REZN-24-18

Rezoning Conditions of Approval

1. **Project Name:** Jamestown Quarry Commercial SIP
2. **Location:** 43.0171, -89.4819
3. **Permit Request No.:** RZ-2573-24
4. **Ordinance No.:** 2024-O-35
5. **Decision Date:** November 19, 2024
6. **Legal Description:** Metes and bounds
7. **Current Zoning Districts:** PDD-GIP
8. **Proposed Zoning Districts:** PDD-SIP

Jamestown Quarry Specific Implementation Plan

ARCHITECTURAL ELEVATIONS

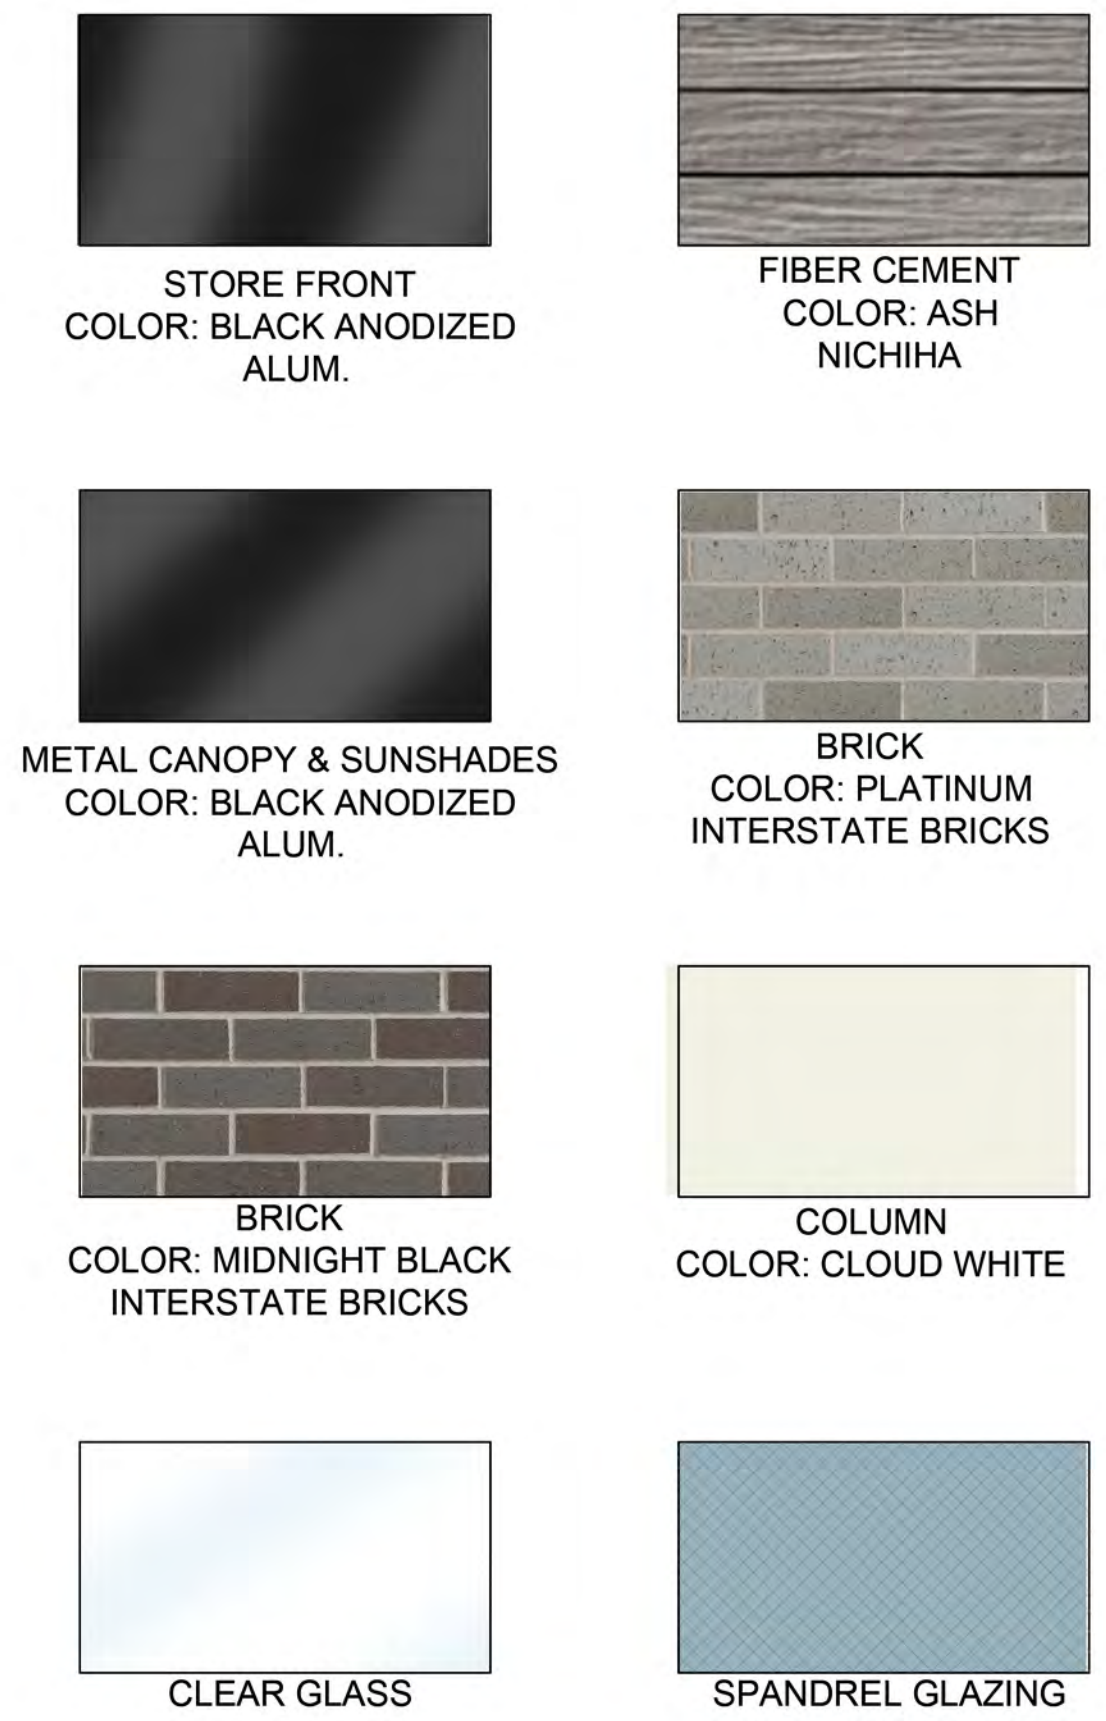
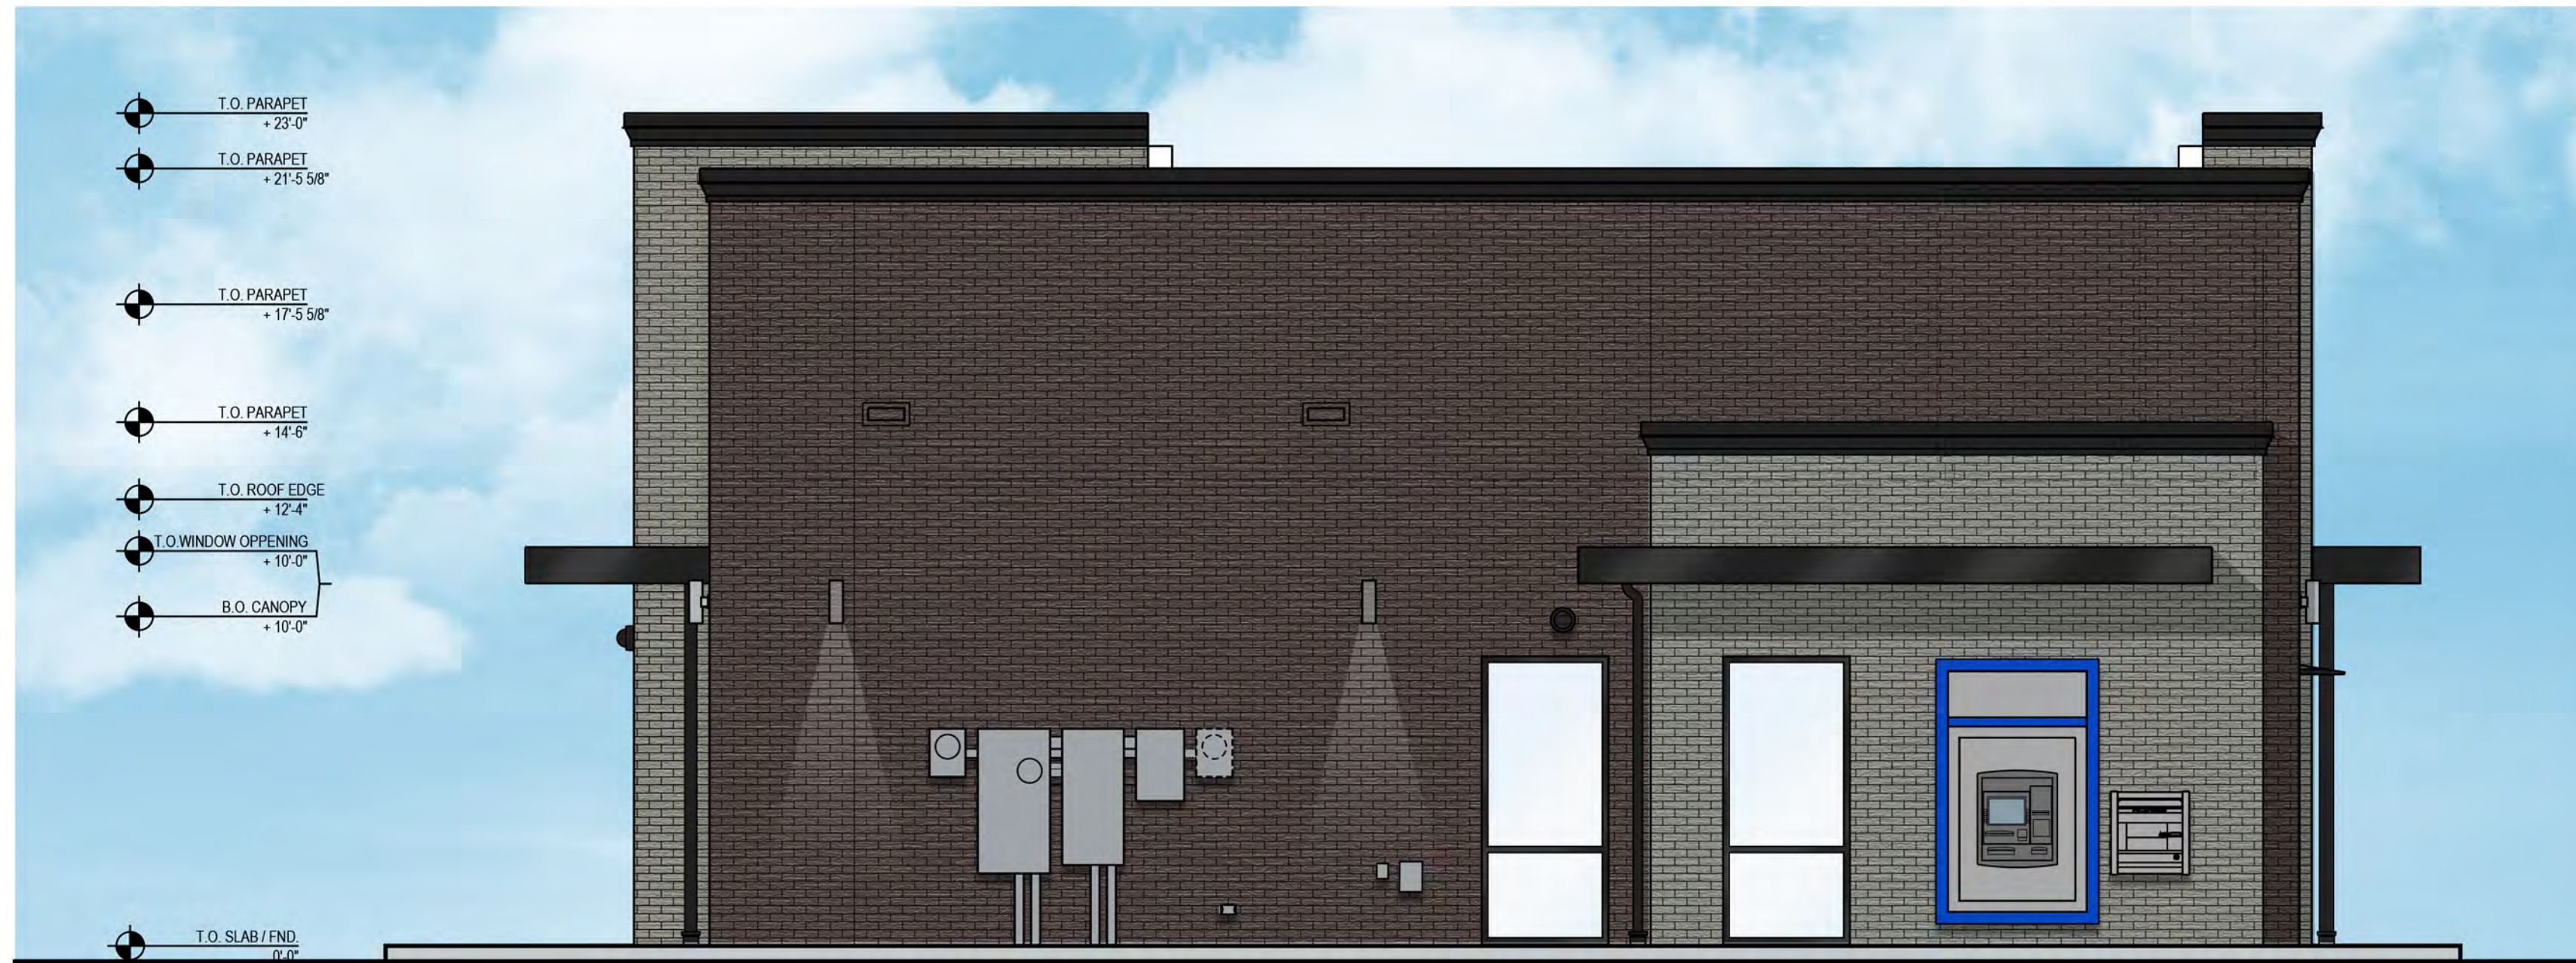
- a. The Chase bank facade does not adequately address the hold corner. Additional height and architectural prominence is required.
 - b. The bank design team is working on a revised design that will further address the needs of the hold corner. Revisions will be reflected further in future ADR submittal.

8. What can be done to the bank on the engage the facade with public view in a more urban form as seen from McKee and Fitchrona roads? We met with Chase and I expected a revision to the proposed plans. The ease elevation appears to leave roof top equipment exposed. Additional height is needed for this building similar to the Taco Bell across the street.

- a. As part of the revisions mentioned in the previous comment, wing walls will be incorporated to address any visibility concerns as it relates to exposed roof top equipment and to cut down on the amount of white TPO visible along the McKee and Fitchrona facades.
